**STAFF RECOMMENDATION**

**1012 Mansfield Avenue**

**July 21, 2021**

**Application:** New Construction – Violation

**A:** Photographs

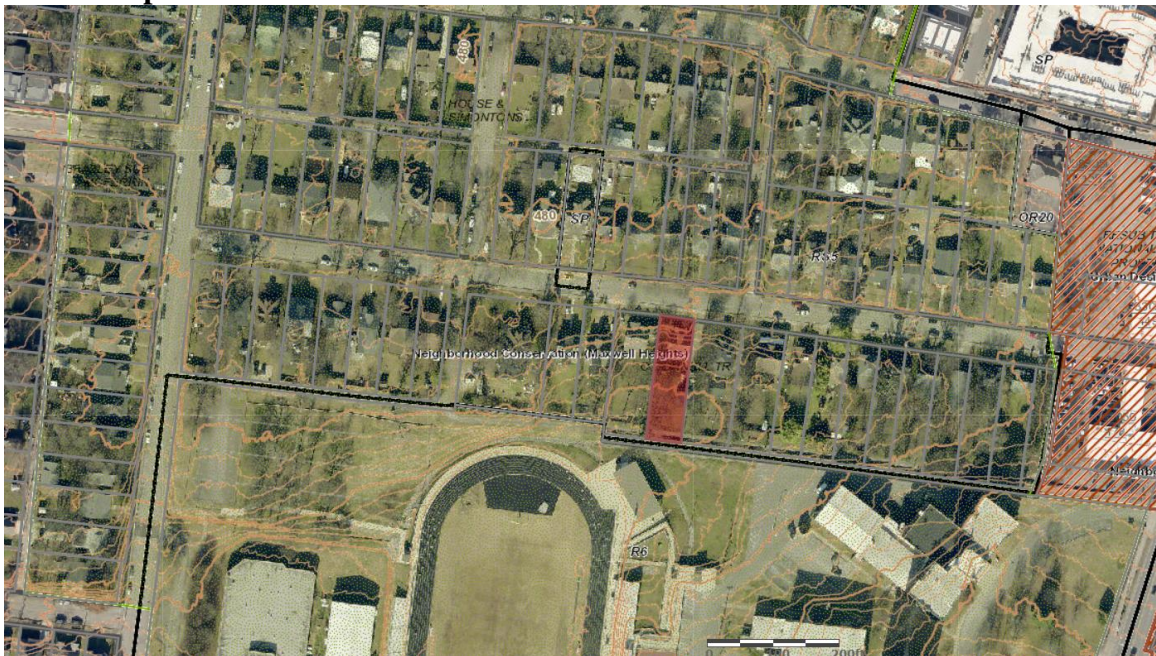
The permit was approved for double hung windows. The windows that were installed are 6/6 double hung with an interior grille (see Figure 1 and 4). The grilles do not meet section IV.C. of the guidelines for materials.

Figure 1: Rear Dormer and Addition

Figure 2: Installed lap siding has a faux grain, specifically called out in the design guidelines as an inappropriate material.

Staff recommends disapproval of the new windows and the siding on 1012 Mansfield Avenue finding that these materials do not meet Section IV.B and IV.C of the guidelines. Staff recommends that the new windows and siding be removed and replaced with compatible materials within sixty (60) days of the Commission's decision.
